Southampton to London Pipeline Project

Responses to Written Representations -
Local Authorities

Application Document: 8.23

December 2019

This drawing is not to be used in whole or part other than for the intended purpose and project as defined on this drawing. Refer to the contract for full terms and conditions.

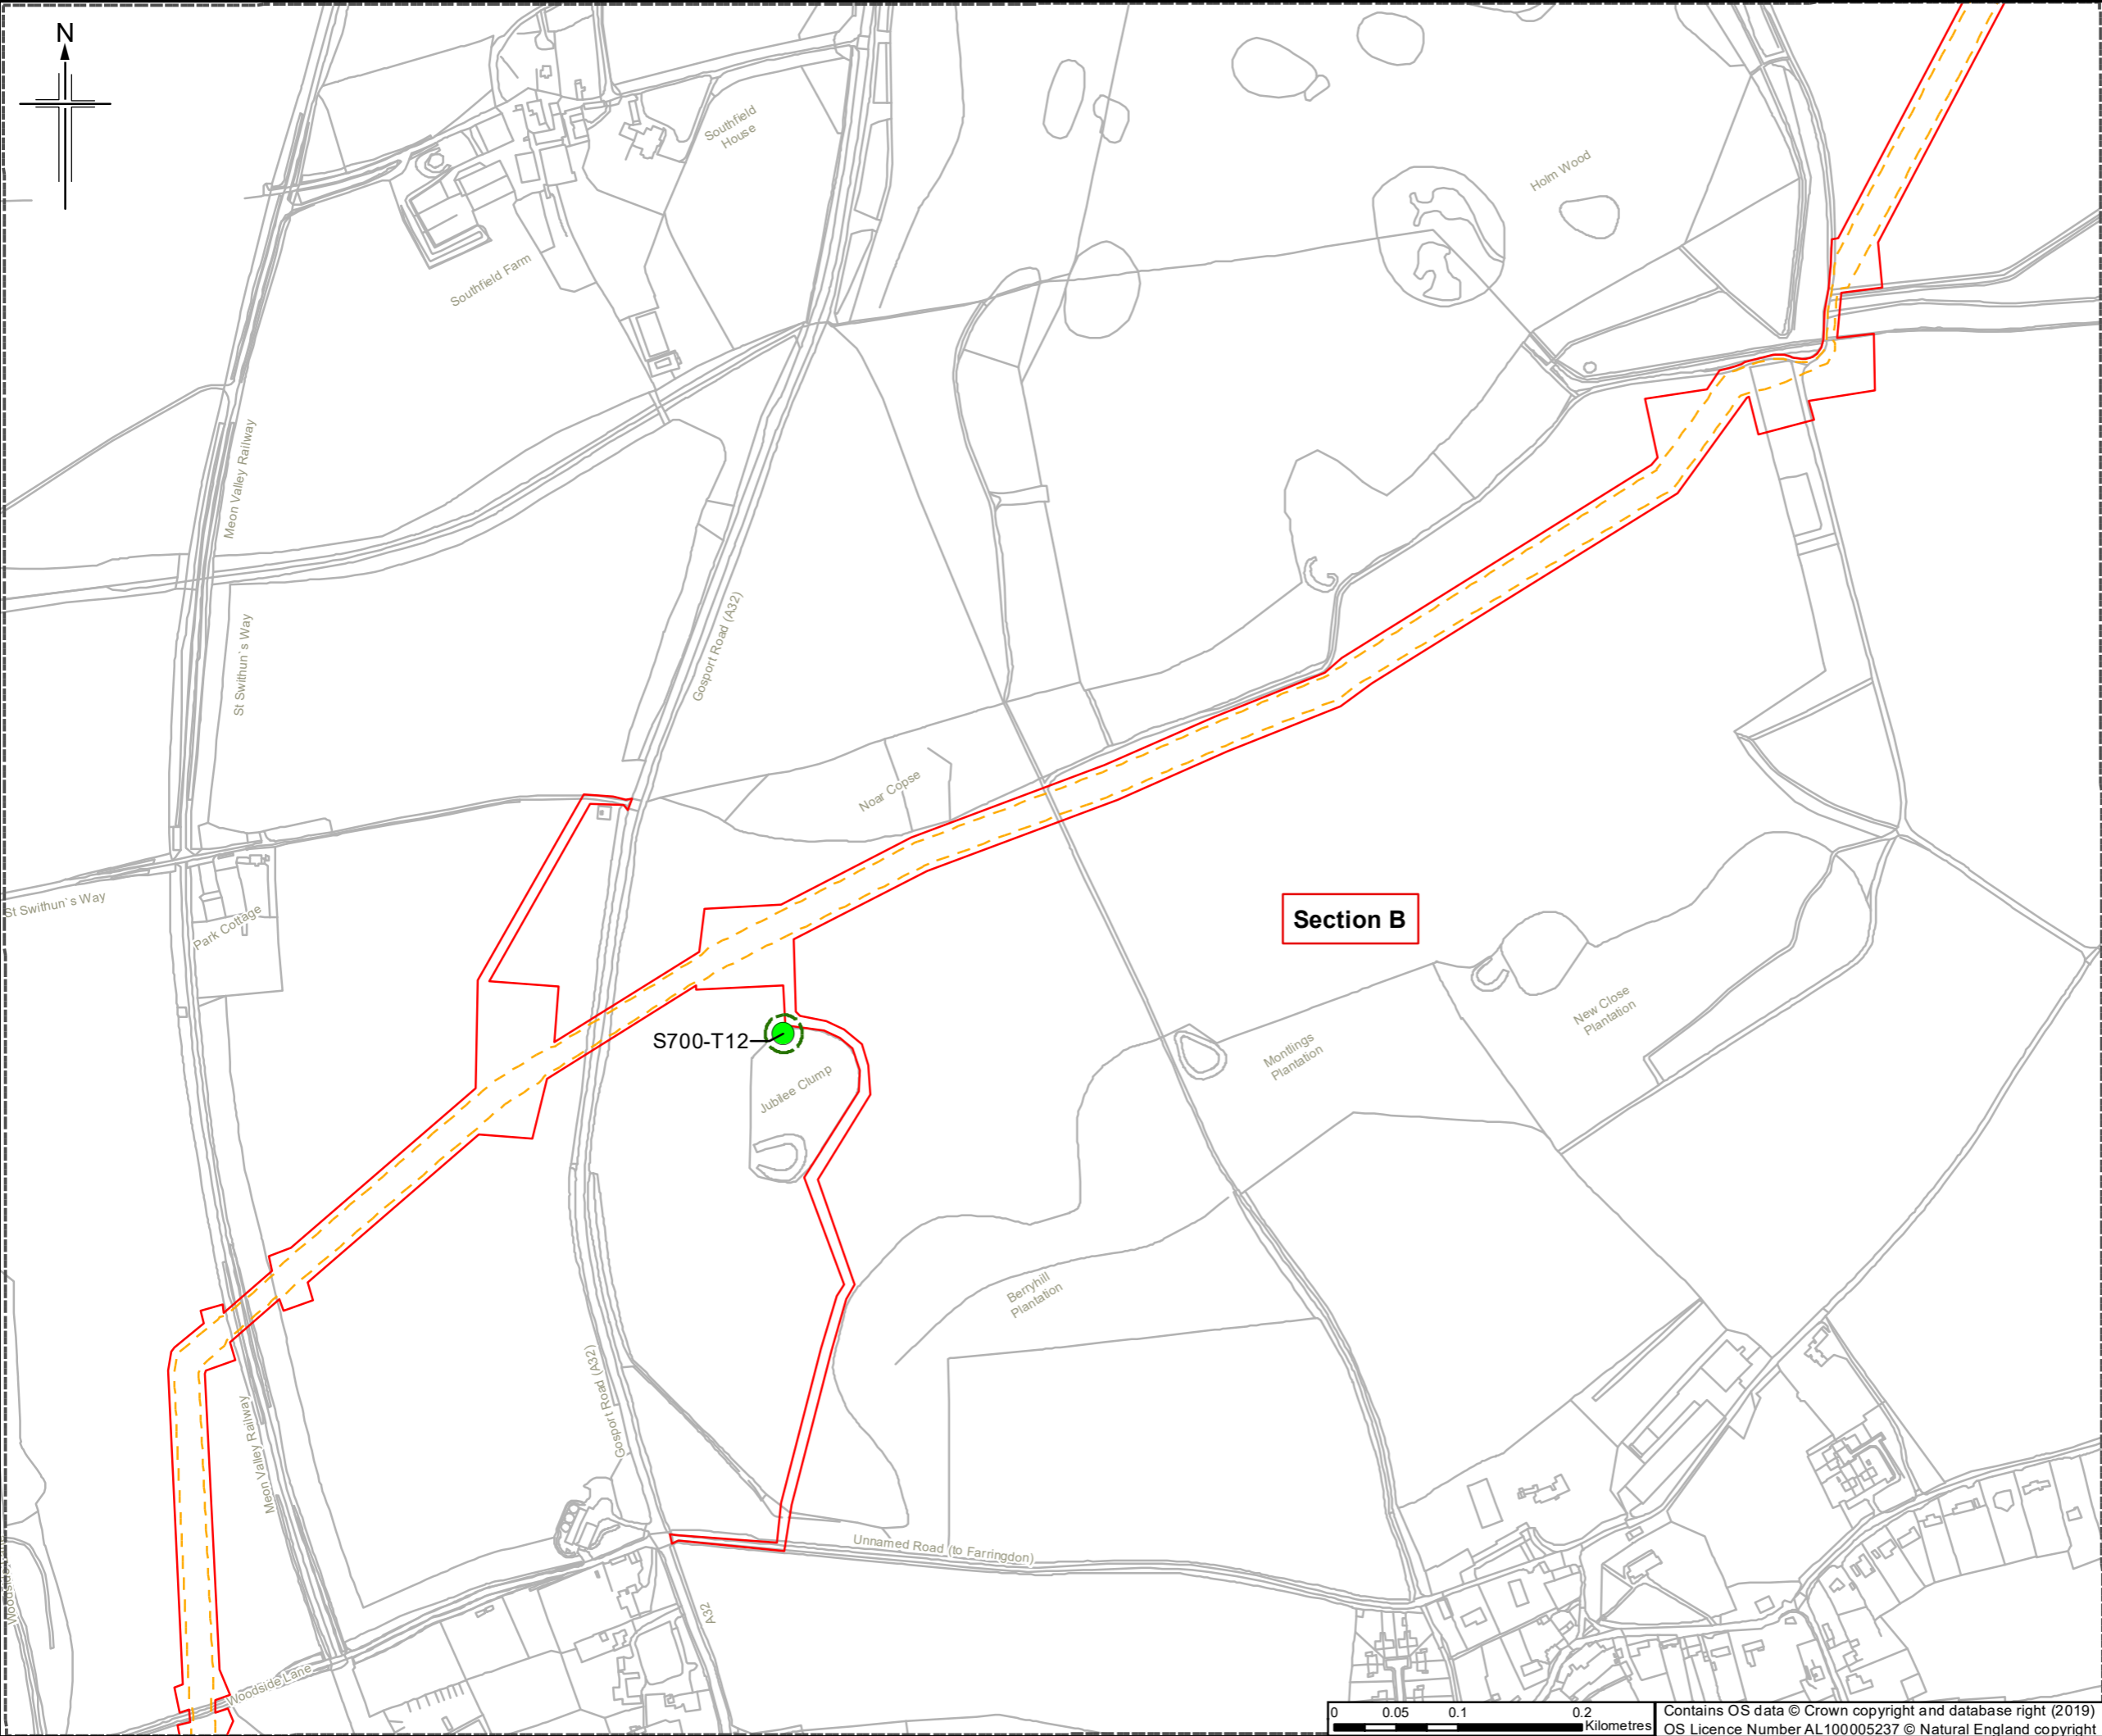
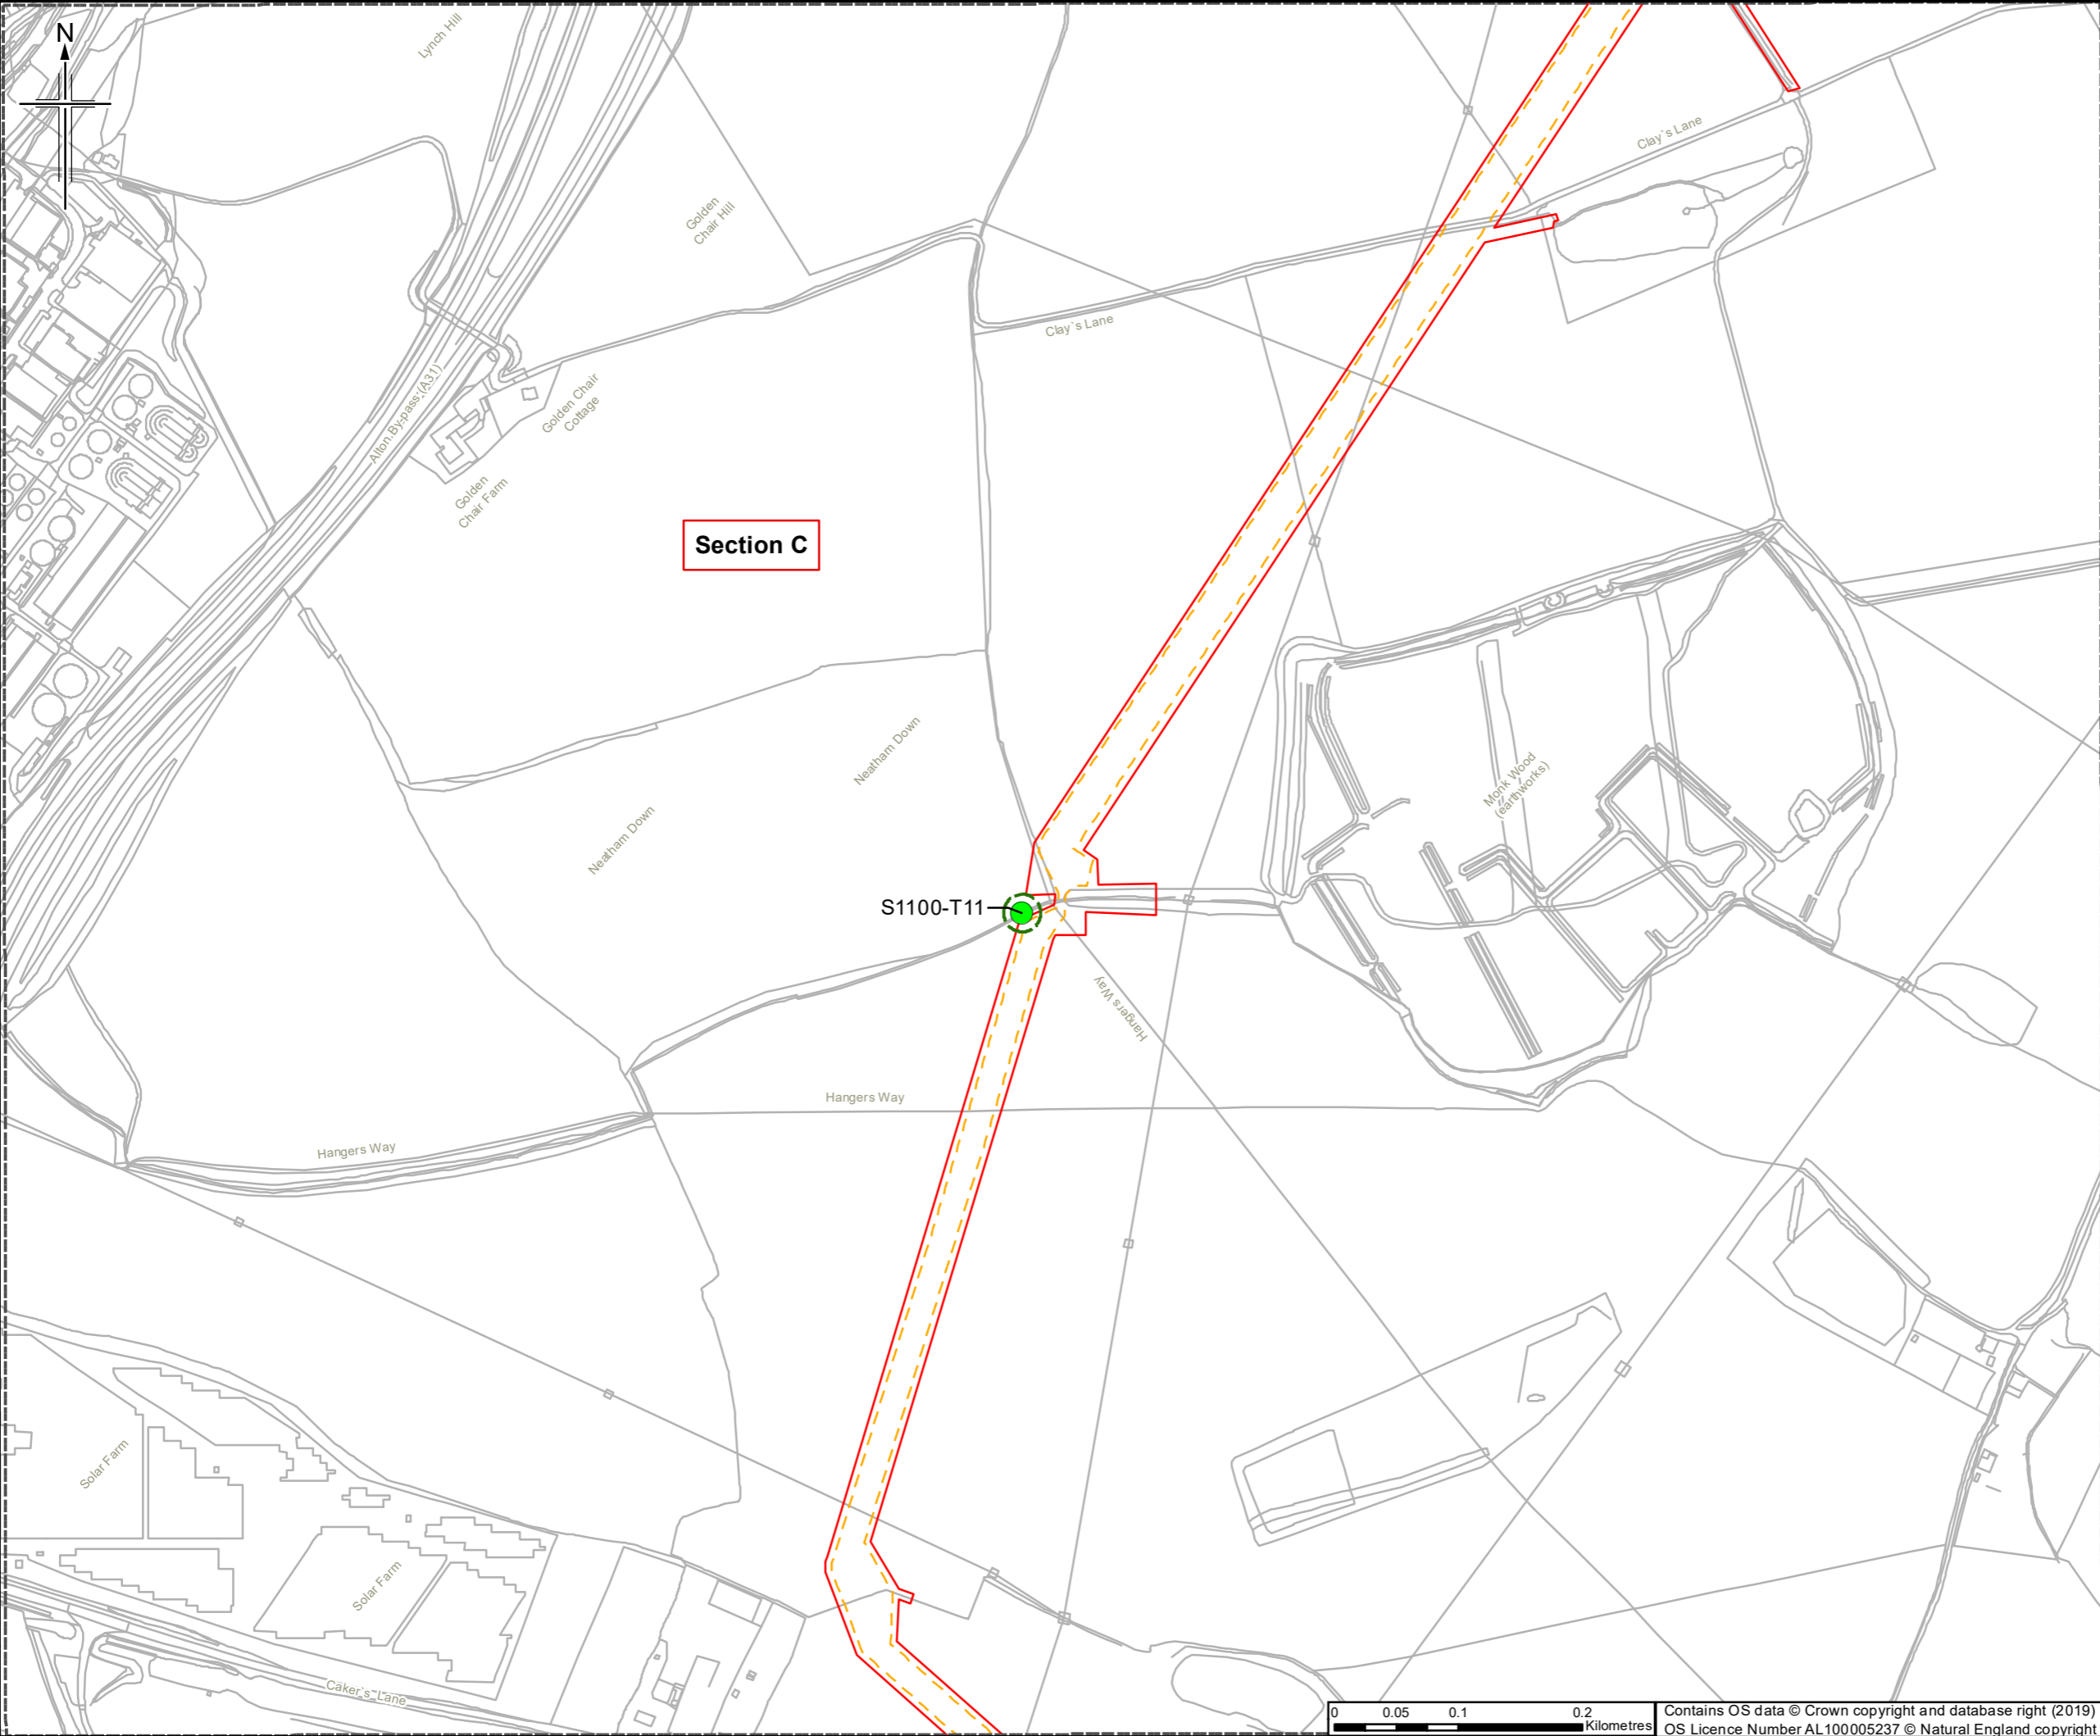
WR Para Ref	Point raised	Applicant response to point raised:
		<ul style="list-style-type: none"> reinstatement hedgerow planting would be relatively quick to establish; reinstatement tree planting would take a little longer to establish, but would have reached approximately 7m in height after 15 years. <p>It is therefore considered that, by year 15, there would be little noticeable change in the landscape character of the National Park when compared to the existing condition, and the effects on the landscape would not be significant.</p>
	<p>In its response to LV.1.25, the SDNPA furthermore requests that the A31/A32 Junction, Northfield Lane (Chawton) logistics hub be added to the list of representative viewpoints set out in the LVIA.</p>	<p>Whilst the Applicant does not consider such a representative viewpoint to be necessary, this has been prepared and is provided at Appendix 1.</p>
<p>Para 3.19 to 3.33</p>	<p>Trees and Woodland</p> <p>The SDNPA sets out concerns regarding potential impacts on, and the applicant's approach to veteran trees and ancient woodland.</p> <p>The SDNPA has requested a plan to identify which of the mitigation hierarchy measures apply to which ancient woodland.</p>	<p>The Applicant has prepared a Technical Note on Ancient Woodland and Veteran Trees (REP2-061) which sets out the approach to reduce the impacts of the project on Ancient Woodland and potential ancient woodland and Veteran Trees and potential veteran trees within 15m of the Order Limits.</p> <p>The Technical Note sets out a hierarchy of mitigation principles, ranging from the use of buffers and ground protection around trees, to the requirement for specialist construction techniques to be used for any unavoidable excavation within root protection areas. The Technical Note has regard to the joint standing advice from the Forestry Commission and Natural England (Ancient woodland, ancient trees and veteran trees: protecting them from development, 2018) when developing the hierarchy of mitigation principles, with avoidance of works within 15m of the edge of ancient woodland and 15m from the stems of veteran trees recommended where practicable.</p>

WR Para Ref	Point raised	Applicant response to point raised:
		<p>Natural England has signed a SoCG with the Applicant (REP1-005), Section 3 of which sets out agreement on matters including:</p> <ul style="list-style-type: none"> • avoiding classified ancient woodland and reducing impacts on potential ancient woodland; • the mitigation proposed in Chapters 7 (Application Document APP-047) and 16 (Application Document APP-056) of the ES; and • working methods in relation to ancient woodland and veteran trees. <p>The Forestry Commission has signed an SoCG with the Applicant (REP2-025), Section 3 of which sets out agreement on matters including:</p> <ul style="list-style-type: none"> • that the proposed approach to mitigating effects on Ancient Woodland, potential ancient woodland and veteran trees, as described in the ES (Application Document APP-056) and the further information included in the Ancient Woodland and Veteran Trees Technical Note (REP2-061) are appropriate; • that appropriate measures have been taken to identify all areas of Ancient Woodland, and areas of Potential Ancient Woodland that do not appear on Natural England's Ancient Woodland Inventory; and • that the Order Limits avoid all areas of existing classified Ancient Woodland. <p>In addition, the Applicant has prepared a plan showing the locations of Ancient Woodland, potential ancient woodland, Veteran Trees and potential veteran trees (see Figure 1 and 2 appended to this document).</p>
